CONTROL ROOM DESIGN REVIEW
and
EMERGENCY PROCEDURE
FUNCTIONAL TASK ANALYSIS
SUMMARY REPORT

W N P - 2

WASHINGTON PUBLIC POWER SUPPLY SYSTEM

SS NO. N-4

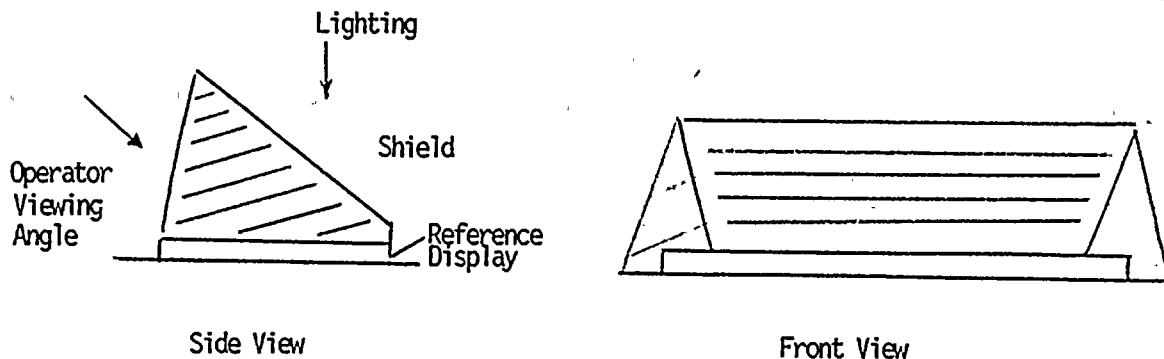
The reference displays on the DEH panel is subject to glare from overhead lighting, which reduces the contrast between the illuminated readout and the background of the reference display. See attached photograph.

ANNUNCIATOR CONTROLS
PROPOSED RELOCATION

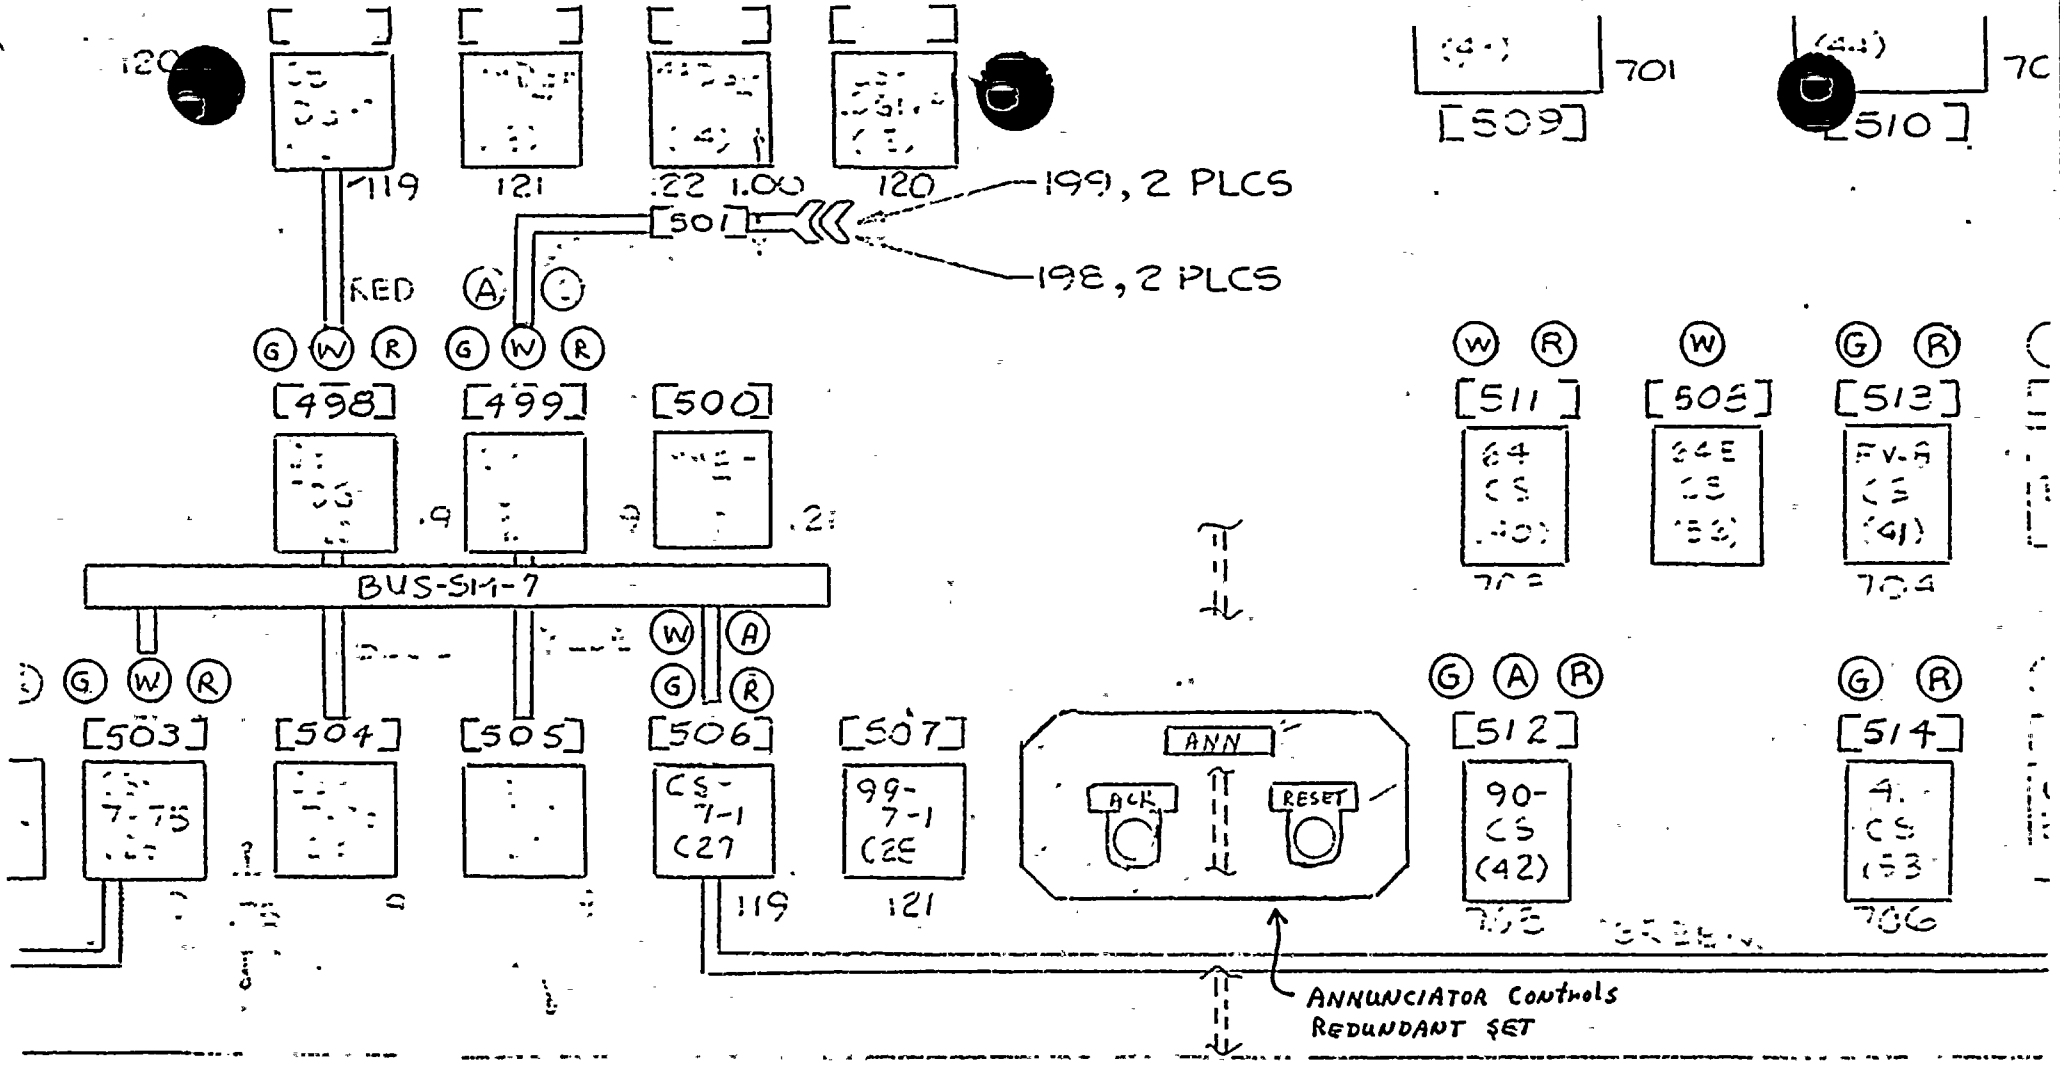
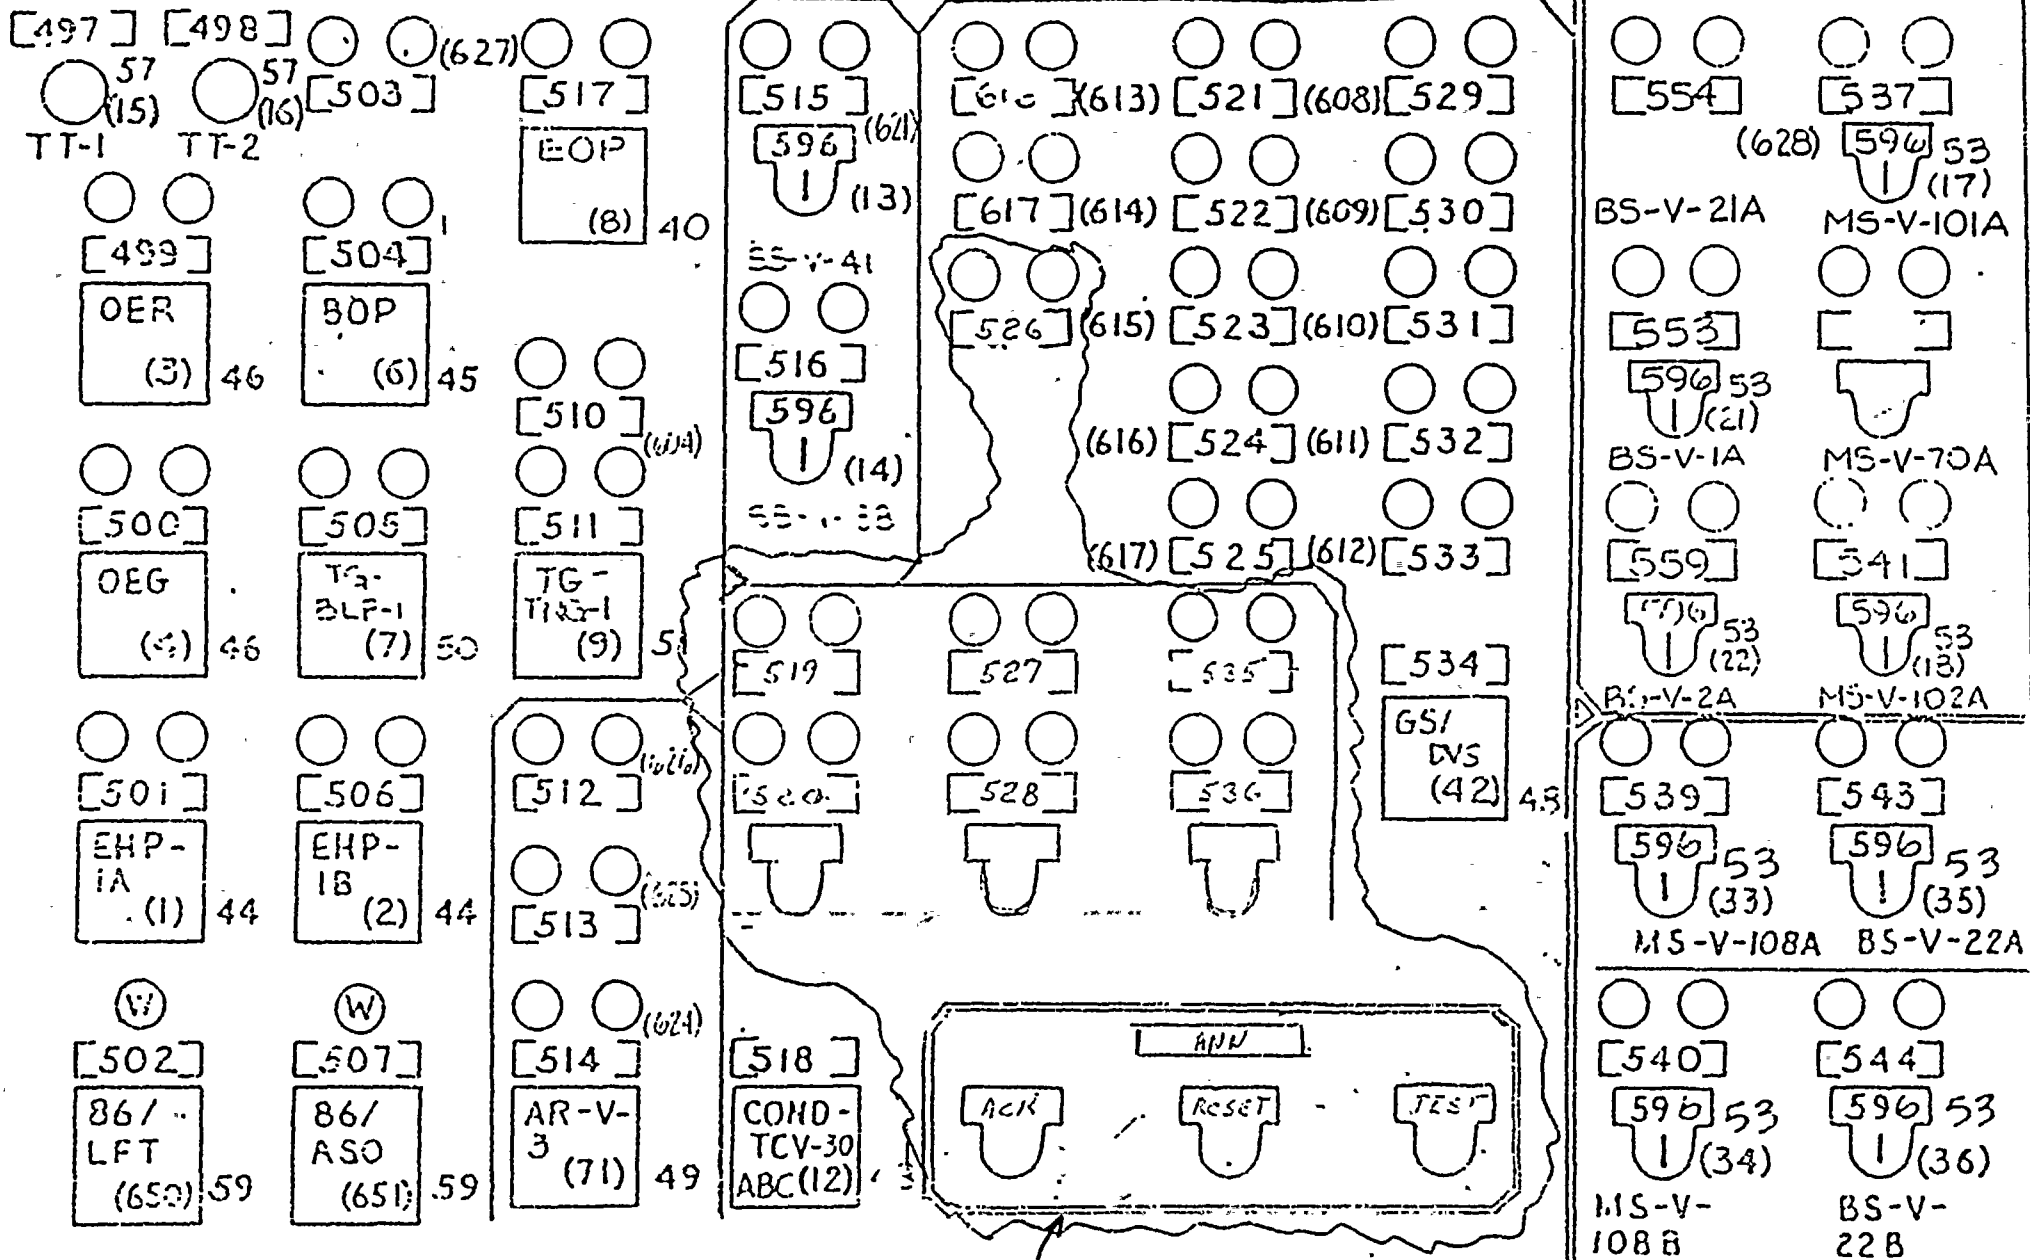
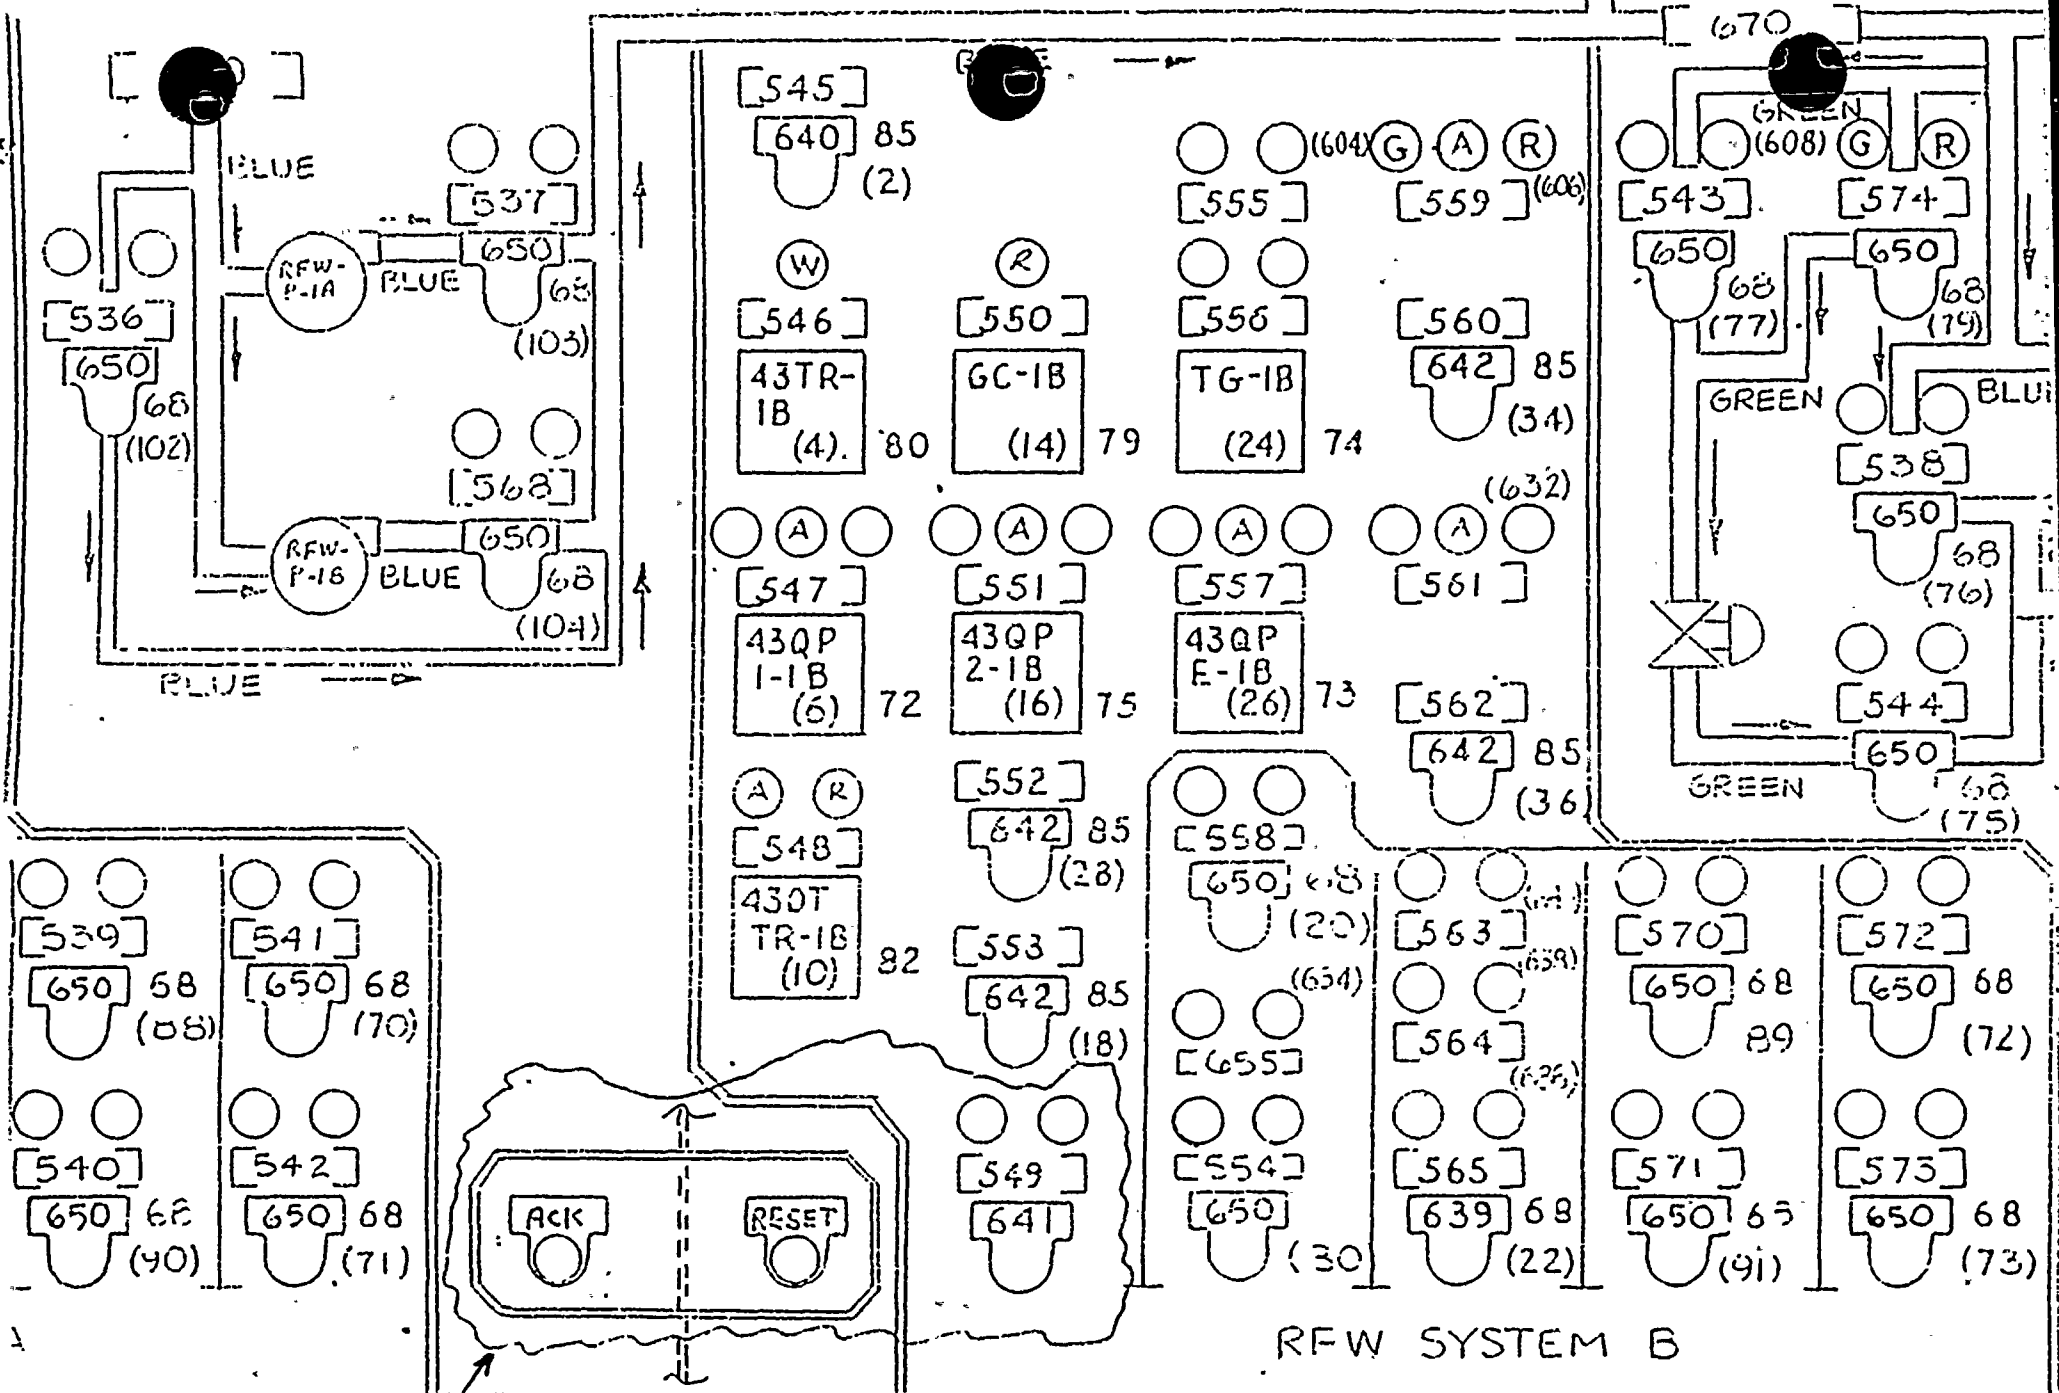
Panel P-800 has left and right horizontal viewing angles of about 22° and 41°. Operational evolutions on this board are not centralized and not all alarm windows are readable from the BOP operator's desk. A redundant set of annunciator response controls will be installed on the left side of the panel during the first refueling outage. The 41° horizontal viewing angle is considered a minimal deviation from NUREG-0700 guidelines, and the present set will be left where they are. As in P-601, a redundant test control will not be included.

The response controls will be relocated to the center of the panel, horizontally arranged along the panel edge for consistency. See attached layout drawing. Besides improving alarm visibility, the proposed relocation will also remove the confusion with the P-840 controls. The relocation will be performed during the first refueling outage.
